TECHNICAL BULLETIN

SUBJECT: GS-204-01 Automatic Siren Disable
BULLETIN #: 0302 Rev.B
RELEASED: 09-10-02
UNIT S/N: All
MODULE S/N: N/A

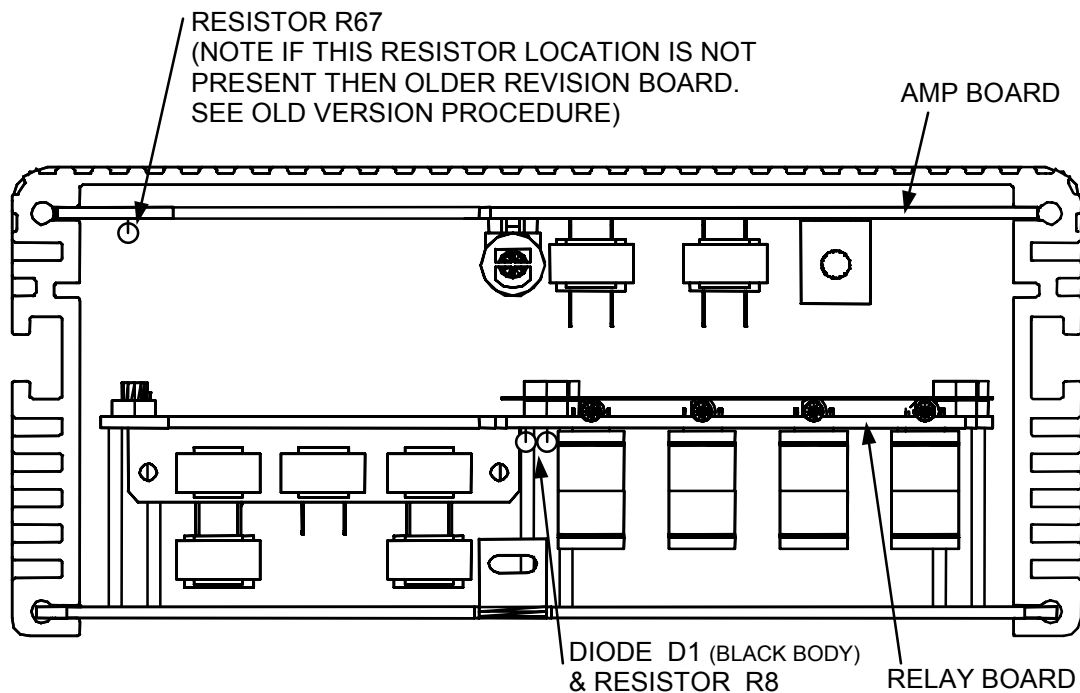
1. Remove faceplate to determine version of siren. (4 screws with 7/64" allen wrench)
If the Resistor R67 location does not exist on the AMP BOARD as shown below, use the OLD VERSION PROCEDURE.

2. On the RELAY BOARD remove D1 diode and R8 resistor with wire cutters.
3. Replace faceplate. (4 screws with allen wrench)
4. Done.
